**CABINET MEMBER FOR HIGHWAY MANAGEMENT
12 OCTOBER 2023**

**BICESTER: A4095 & B4100 BANBURY ROAD – PROPOSED 30MPH
SPEED LIMITS AND RAISED SIDE ROAD ENTRY TREATMENT AT
FRINGFORD ROAD**

Report by Corporate Director, Environment and Place

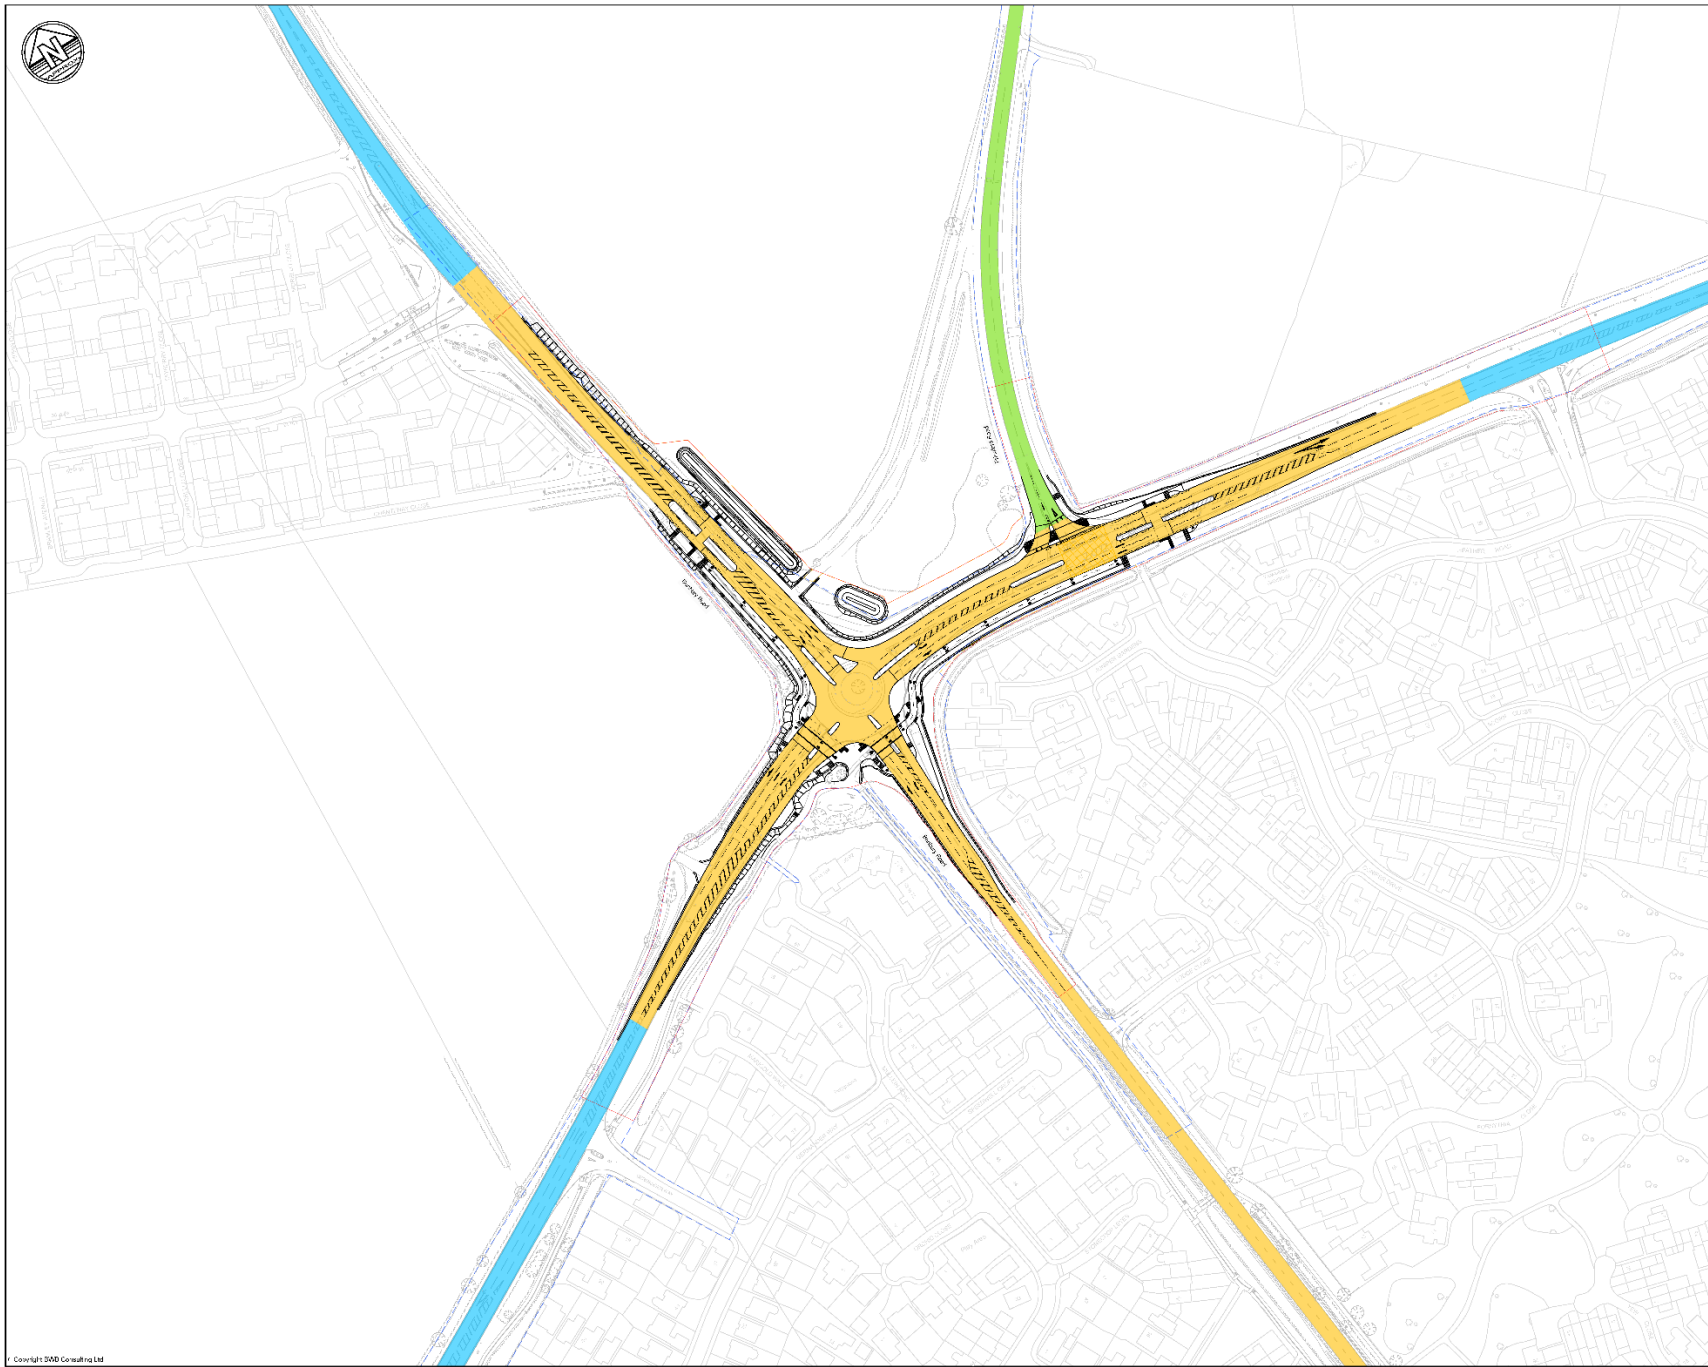
- a. The proposals were unnecessary.
- b. The proposals would lead to congestion and traffic disruptions.
- c. The current arrangement was functional and did not require any changes to what was working.

- d. The speed limit in the area had recently been changed to 40mph, and that a further change to 30mph was unnecessary and unjustified, would disrupt traffic and would encourage road users to opt for residential roads for quicker access to the surrounding areas.

- e. Some cited that there had been insufficient time to assess the effect of the 40mph speed limit prior to advertising for a further change to 30mph.

- f. In terms of the raised side road entry proposal, there was concern that these structures tend to damage vehicles and motorcycles and would introduce difficulty to drivers at the junction, particularly as they attempt to manoeuvre over the raised table around the turn when attempting to join the adjoining carriageway.

- g. There were concerns that the raised side road would harm the environment due to the increased emissions caused by slower moving traffic and congestion in the area.

19. Officers appreciate the level of concern that has been raised. A large number of the responses assumed the existing roundabout was to remain or were in response to the overall plans to signalise the junction.

20. Caversfield Parish Council raised concern about the proposed raised junction, but most of their concerns relate to the overall junction design at Banbury Road. The proposals in this report are not specifically about the signalisation but the lowering of the speed limits will make that layout safer by increasing control of the traffic flow to improve safety for both road users and active travel users.

21. There were concerns from some residents and local councillors that the speed reduction would increase air quality and congestion issues, however, the lower speed in itself will not result in these outcomes.

22. The raised side road entry treatment has been proposed to provide safe crossing for active travel users at Fringford Road, in line with policies to encourage an increase in trips by walking, wheeling or cycling. The local councillor reports general support from residents who use this road and currently find it dangerous. The raised side road entry treatment will encourage active travel in this area and provide improved access to a wider range of users, while discouraging speeding in the area. The 30mph limit is required as road humps are not permitted in higher speed limits. The 30mph limit will help to enhance the safety of road users and active travel users even further. The extents of the speed limits were recommended by Safety Officers and Design Consultants, with consideration given to the potential congestion and traffic disruptions that may potentially be caused.
